RE: Outline of January 18, 2010 Meeting

Zone Change No. 2009-15Z

JOINT PUBLIC HEARING AGENDA ITEM MEETING OF JANUARY 18, 2010

Re: Pearland Retirement Residence Planned Development,
Zone Change No. 2009-15Z

Exhibit A - Site Plan

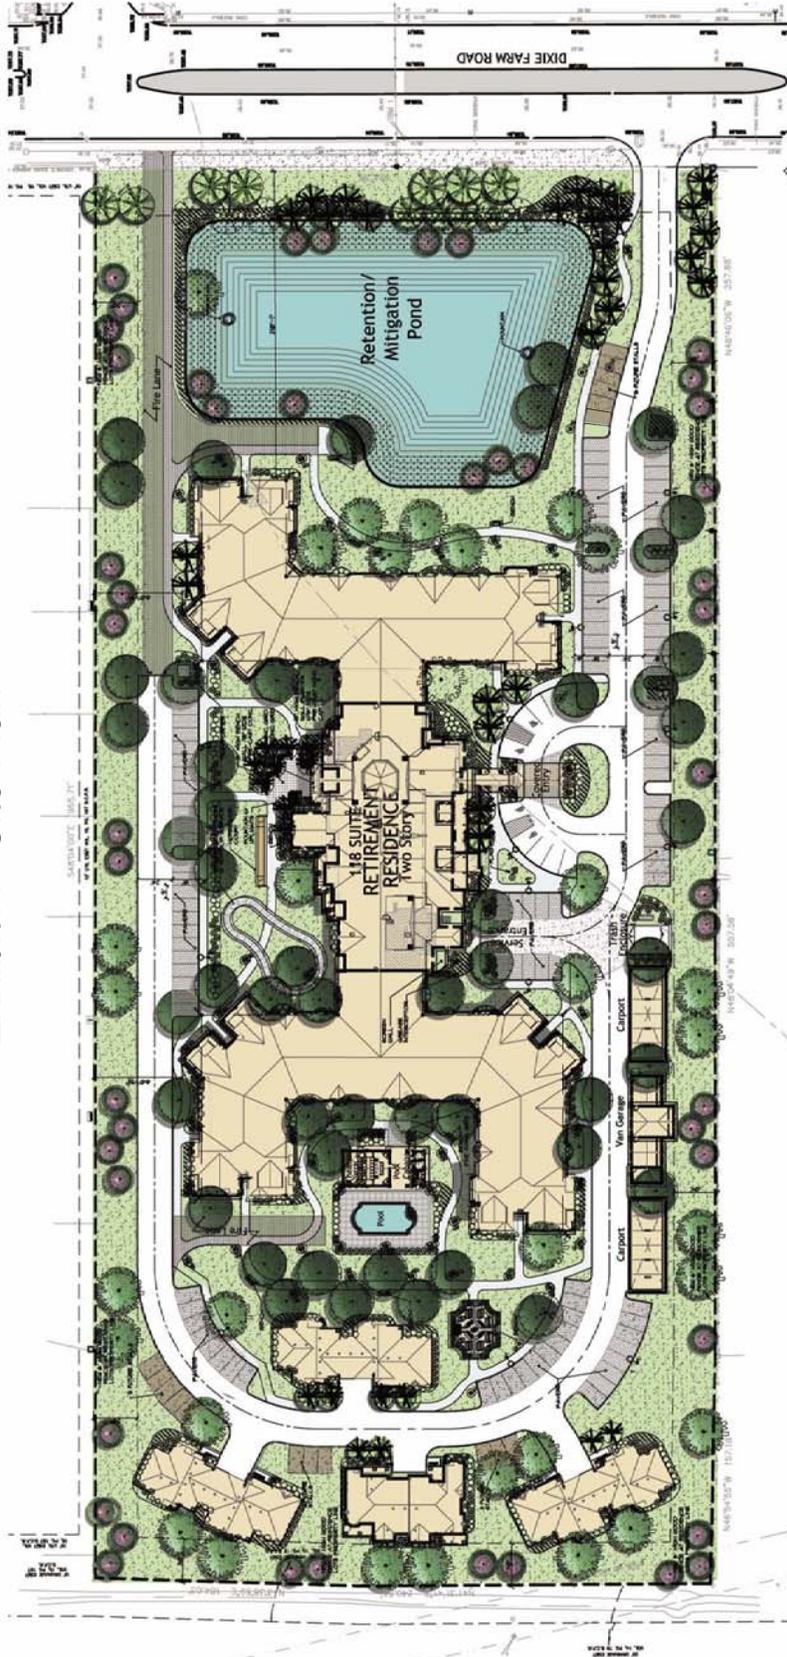
- 5) Underline "except a kitchen is not included in the suites".
- 6) Underline "provide private van transportation for their use".
- 7) Common open space needs to be shaded or crosshatched on the site plan and meet the Unified Development Code requirements: common open space must be at least 80 feet wide and at least 113,400 square feet must be provided (calculated at a rate of 900 square feet per dwelling unit.)

- 8) Show future parking spaces on the site plan and show cottage/duplex parking.
- 9) Height-state what the maximum height is required by the Unified Development Code and what is proposed. The maximum height permitted in the proposed Multi-Family Zoning District is 35 feet.

- 6) Add the storm water calculations to the PD Document and label it as an exhibit.
- 7) Common open space needs to be shown on the site plan and addressed in the PD Document. Common open space needs to be at least 80 feet wide in

order to qualify for common open space. Please cross hatch these open space areas on the site plan for ease in identification.

- 1) City Council, Planning and Zoning, and Staff would like to see additional parking. The amount of parking is not sufficient for the proposed use. Parking for the suites/units are the only parking spaces provided. Please provide a breakdown of parking for the other uses on the premises such as: the common areas, the salon, recreational areas, and the dining hall, visitor parking etc. In the past, similar uses have been approved with 1.3 spaces for one bedroom units, and 1.75 spaces for 2 bedroom units, and 1 space per 100 square feet of gross floor area for a clubhouse.

Please see revised site plan and chart below for the proposed parking ratio.

Note that most of our residents do not drive, we provide private van transportation for their use. Van transportation is included in the rental price. The van is available at all times to take the residents to places they need to visit, such as banks, medical offices, shopping areas, etc. Therefore we are proposing a parking deviation allowing the ratio of 1.3 spaces per suite.

Exhibit K - Open Space Plan

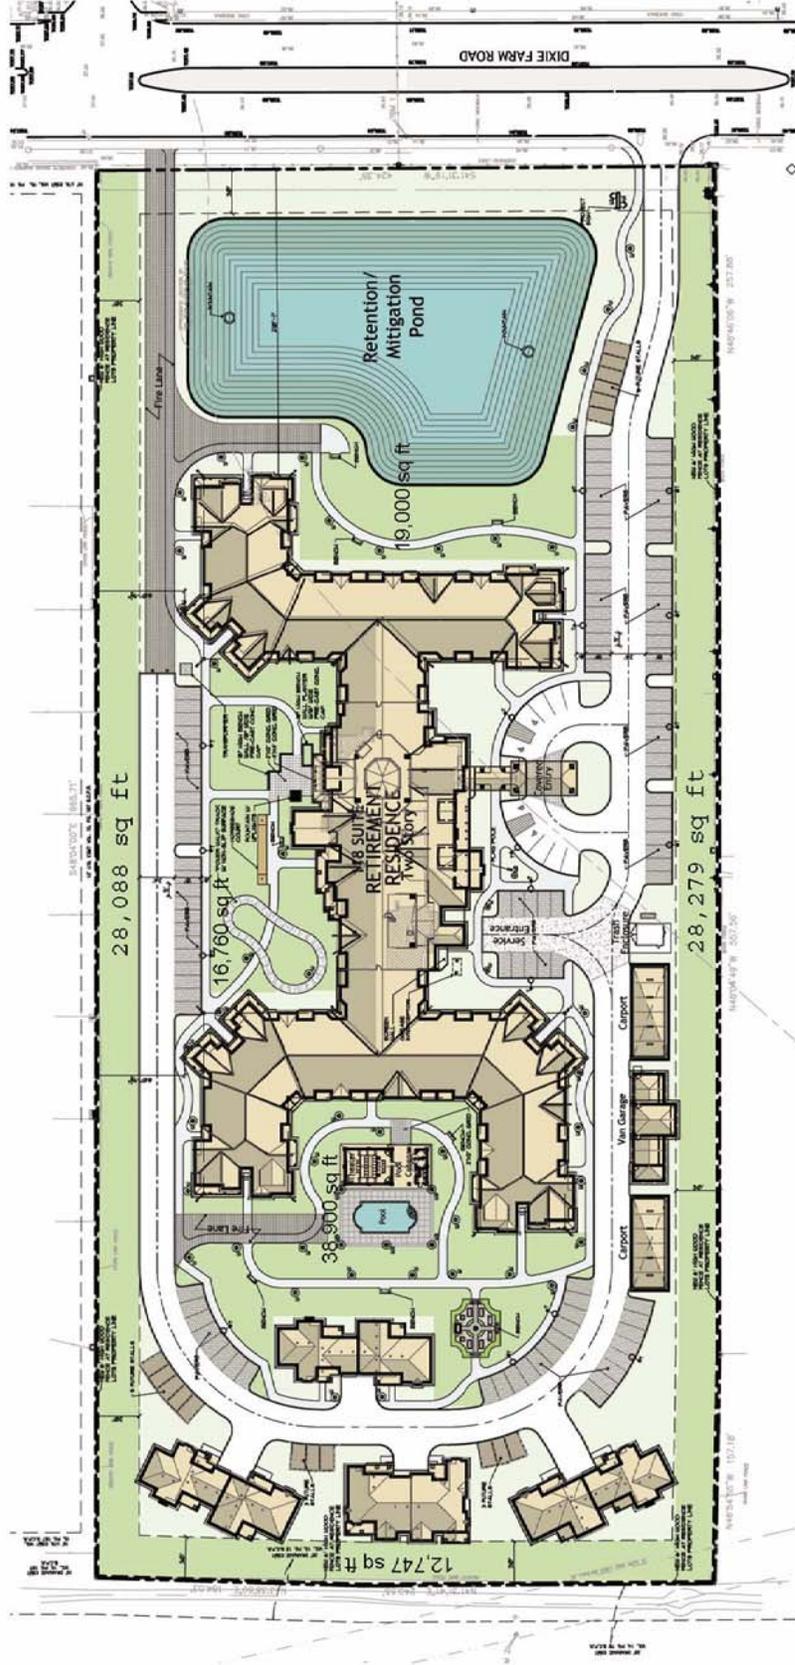
COMMON OPEN SPACE: The Unified Development Code requires that common open space must be at least 80 feet wide and at least 115,200 square feet must be provided (calculated at a rate of 900 square feet per dwelling unit). The applicant provides for 128 units at a rate of 900 square feet of open space, which equals 115,200 square feet of common open space. The site plan as submitted shows that some of the areas calculated for common open space do not meet the 80 foot width requirement.

- 4) On page 3, for common open space a minimum of 80 feet wide is required in order to consider this part of common open space. There are some green shaded areas on the site plan that do not meet these requirements. In addition, please change the wording in the chart to “Required Common Open Space”.

Common Open Space
 Required 128 units x 900 sq ft = 115,200 sq ft
 Provided 141,600 sq ft
